CHESAPEAKE BAY FOUNDATION

House Bill 1465

**Exelon Generation Company LLC
Conowingo Hydroelectric Project**

**CHESAPEAKE BAY FOUNDATION, INC.'S COMMENTS ON
OFFER OF SETTLEMENT**

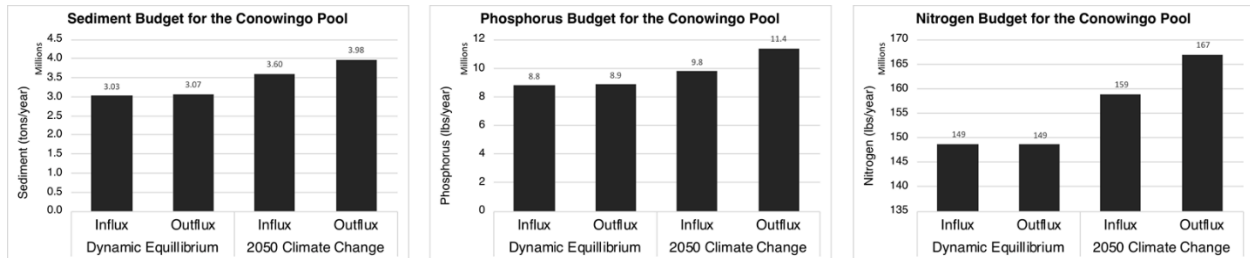
Recent model simulations of the effects of climate change on infill in the Conowingo Reservoir, or "Pool," indicate that by 2050 outputs of nutrient and sediment from the Project will *exceed* inputs, meaning the Dam itself will become a *source* of these pollutants (Figure 1) within

the new license term.¹⁵ In turn, these additional pollutants will have effects on downstream water quality, specifically the attainment of dissolved oxygen standards.

As noted earlier, modeling estimates of the effects of climate change by scientists at the Chesapeake Bay Program show that by 2050, Conowingo Dam will be releasing more pollutants than the pollutants coming downstream from various sources further up the Susquehanna River. Model estimates indicate that at that point, sediment, phosphorus, and nitrogen outputs are greater than inputs – by approximately 9%, 15%, and 5% respectively.⁴⁸ Nothing in the Settlement Offer addresses those water quality impacts, therefore the Commission should reject its terms.
